**CONSTRUCTION BULLETIN
No. 1**

Institution: Calipatria State Prison - CAL

Reference: Project #18-045, Replace Roof, Phase 11, including

Description: This bulletin is to revise the roof slope to the existing ¼” per foot and to revise the parallel AHU’s crickets to 1 ½” per foot on the upper roof per RFI 003 response. Plans and Sections have been revised show the updated roof slope. Parapet,

DATE: 07/31/2024
SHEET NUMBER
GA2.1
OF # SHEETS V1

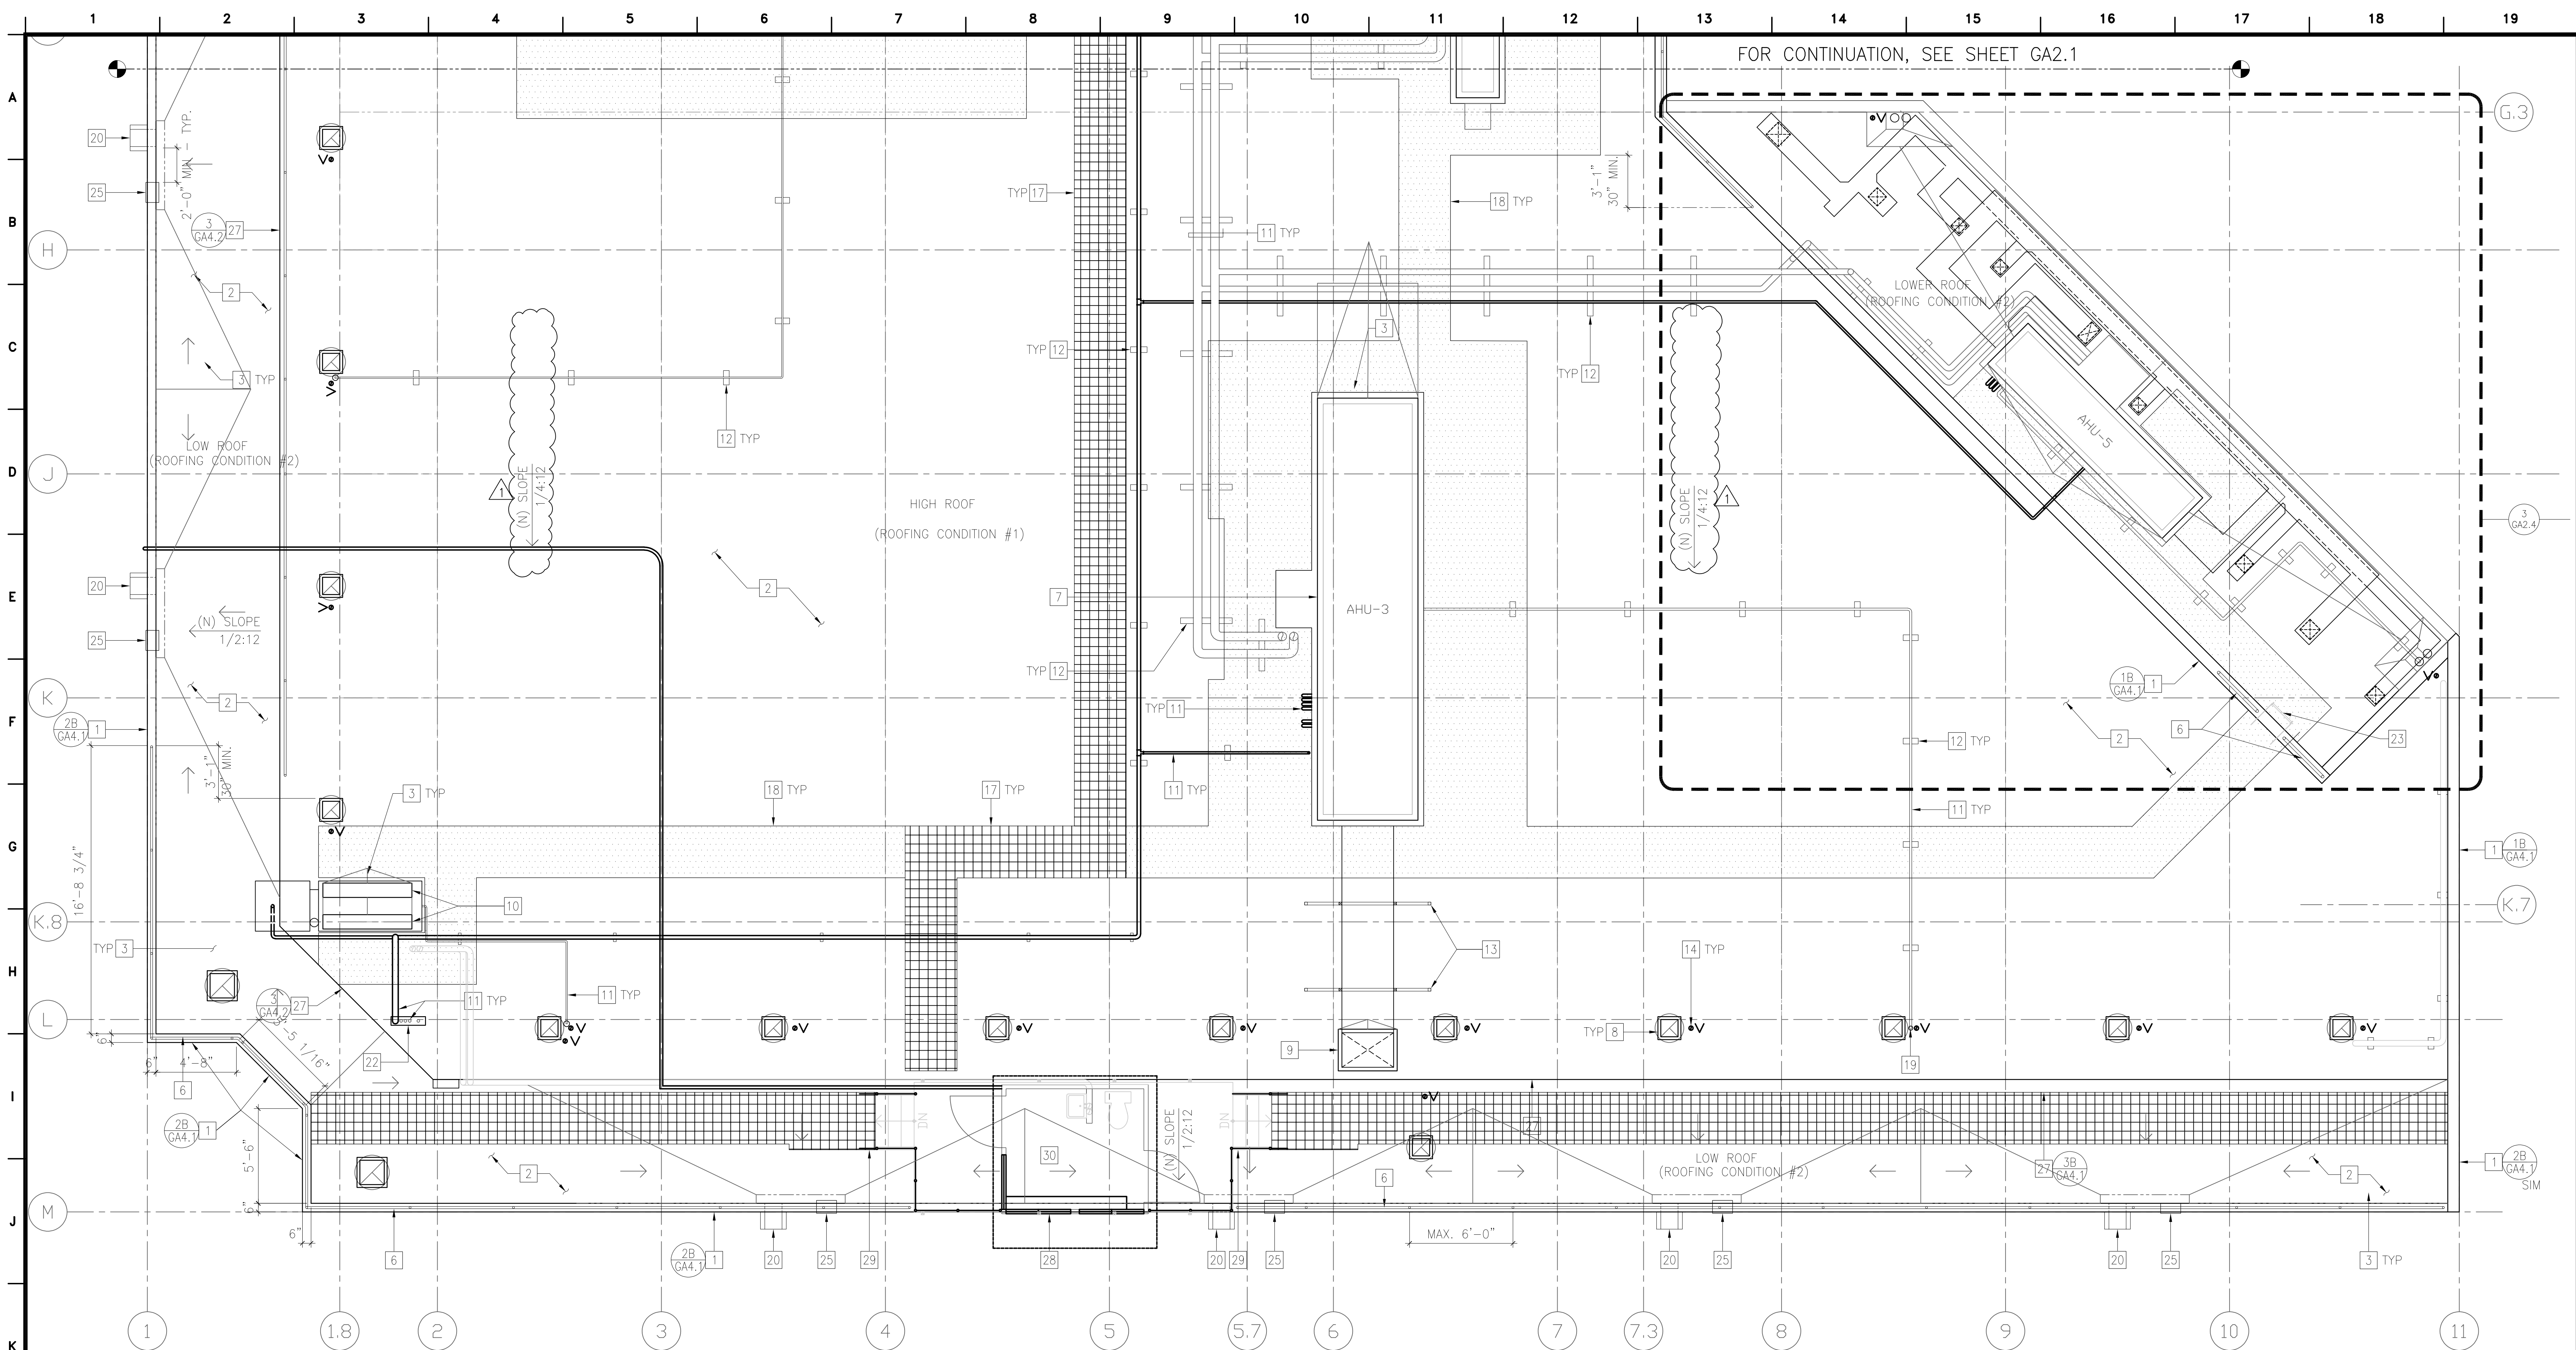
2. Sheet GA2.1:
 - a. Revised roof slope to $\frac{1}{4}$ " per foot,
 - b. Revised spot elevations at upper roof.
 - c. Revised keynote #18.
3. Sheet GA2.2:
